Docket: : A.13-10-020
Exhibit Number : _____
Commissioner : Liane Randolph
Admin. Law Judge : Hallie Yacknin
ORA Project Mgr. : Christopher Myers
: Barry Flynn
: Robert Jenkins
: Pushkar Wagle

OFFICE OF RATEPAYER ADVOCATES
CALIFORNIA PUBLIC UTILITIES COMMISSION

AMENDED
PREPARED REBUTTAL TESTIMONY
ON THE APPLICATION OF SOUTHERN CALIFORNIA
EDISON COMPANY (SCE) FOR A CERTIFICATE OF PUBLIC
CONVENIENCE AND NECESSITY FOR THE WEST OF
DEVERS UPGRADE PROJECT AND FOR AN INTERIM
DECISION APPROVING THE PROPOSED TRANSACTION
BETWEEN SOUTHERN CALIFORNIA EDISON AND
MORONGO TRANSMISSION LLC

Figure 1: A Comparison of Renewable Resources Selected in the Riverside East CREZ under Past CAISO TPPs and the RPS Portfolios Developed Using RPS Calculator Version 6.1

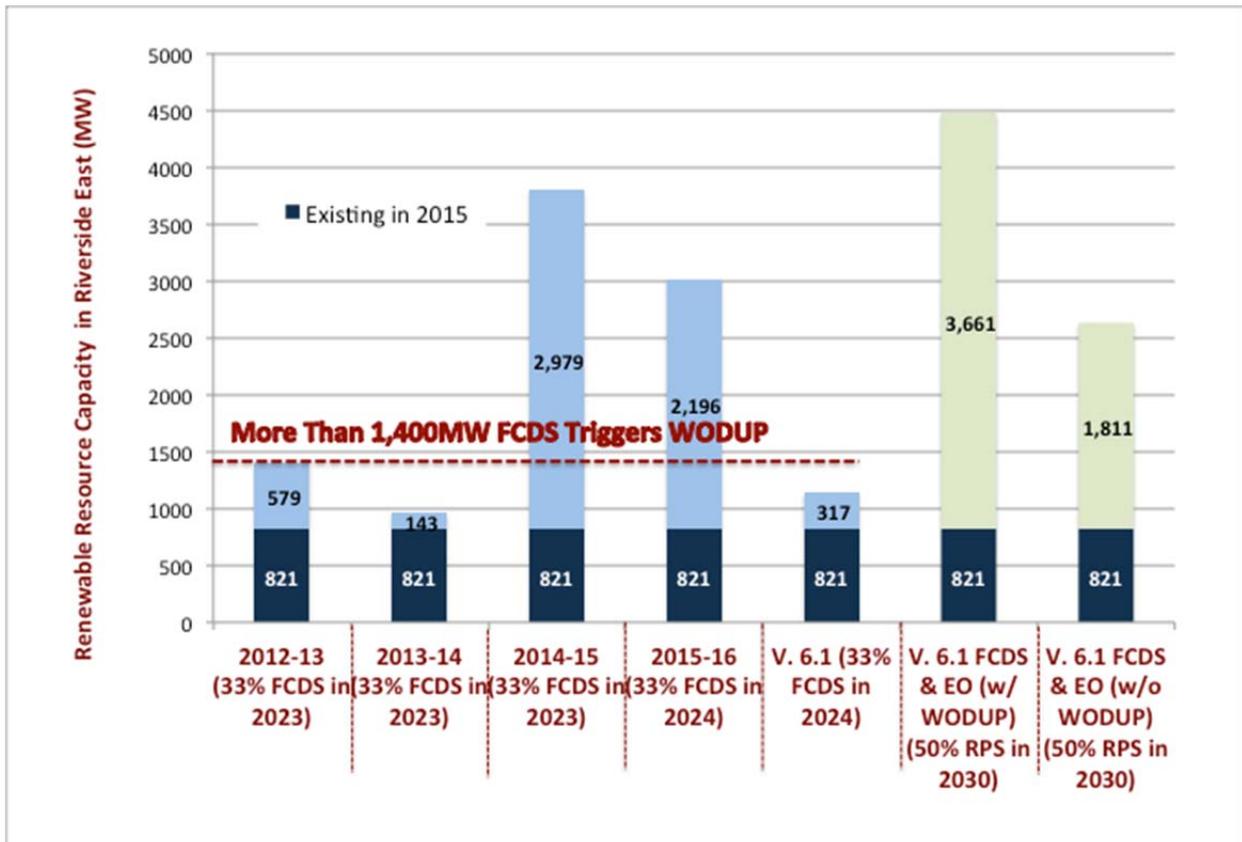
4
 5 **Figure 1** summarizes the RPS portfolio resources selected in the *Riverside East*
 6 CREZ under the past CAISO TPPs as well as the RPS Portfolios developed using the
 7 RPS Calculator Version 6.1. In summary, we make the following observations:

- 12 • Varying levels of RPS resources were selected in the
 13 *Riverside East* CREZ as shown in the first four blue bars in
 14 Figure 1. The 2012-13 and 2013-14 TPP portfolios did not
 15 trigger any need for the WODUP, whereas the 2014-15 and
 16 2015-16 TPP did identify the need for additional transmission
 17 capacity as the PPA projects identified at that time exceeded
 18 the existing FCDS transmission capacity. While the RPS
 19 calculator version 5 selected the WODUP, had the Interim
 20 Upgrades been an available option, the Interim Upgrades
 21 would have been sufficient to accommodate the capacity
 22 associated with these PPAs.¹⁹

WODUP, *does not identify any need for the WODUP* either to meet 33% RPS by 2024 assuming all resources to be FCDS (see the fifth blue bar from left in Figure 1) or to meet 50% RPS by 2030 assuming a combination of FCDS and EO resources (see the rightmost green bar in Figure 1).

- A very large capacity of RPS resources can be built in the *Riverside East* and *Palm Spring* CREZs on the existing WOD capacity (without the WODUP) if their delivery status is EO.
- All versions of the RPS calculator, including v. 6.1, understate the capability of the existing system as they ignore the transmission capacity added by the Interim Upgrades.

Figure 2: Solar Generation Delivery Profile³⁶

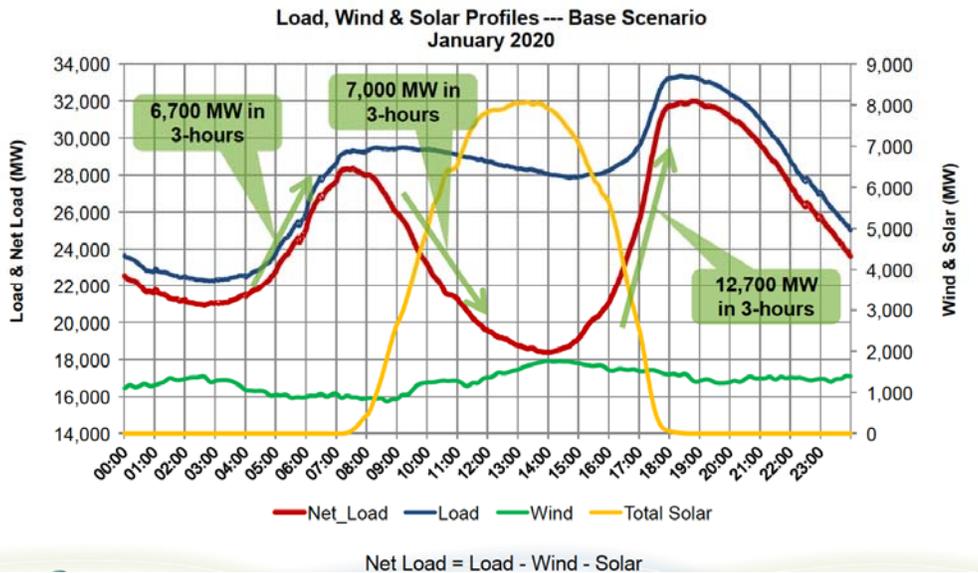
7 **Figure 2** shows a solar generation delivery profile for the CAISO. The solar
8 energy production peaks in the early afternoon and then declines and eventually
9 disappears between 5:00 pm and 6:00 pm. **Figure 3** shows what has come to be known as
10 the “duck curve.” This is a curve developed by the CAISO to highlight the **net load**. Net
11 load is the difference between forecasted load (gross load) and expected electricity
12 production from variable generation resources such as solar generation. Overgeneration
13 is the condition represented by the “belly” of the duck curve. Overgeneration exists
14 when net load falls below the minimum generation level of other resources that must be
15 on-line. Overgeneration can be solved by curtailing renewable generation, retrofitting
16 existing natural gas plants to reduce minimum generation levels, building load through
17 demand response programs when overgeneration conditions are expected, shifting load

Figure 3: The “Duck Curve”³⁷

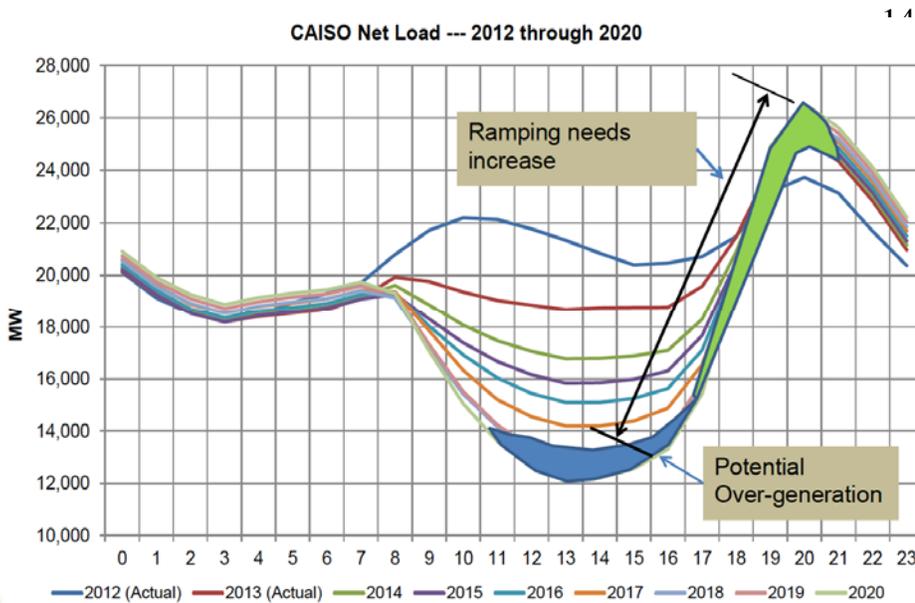
15 The “duck curve” also highlights the shift in the net peak load associated with
16 renewable integration. Rather than the traditional daytime peak, the net peak load is
17 shifting to the evening hours, around 8:00 pm in this example. This is a period when
18 solar generation (without integrated storage) is expected to have little or no contribution
19 to system flows.
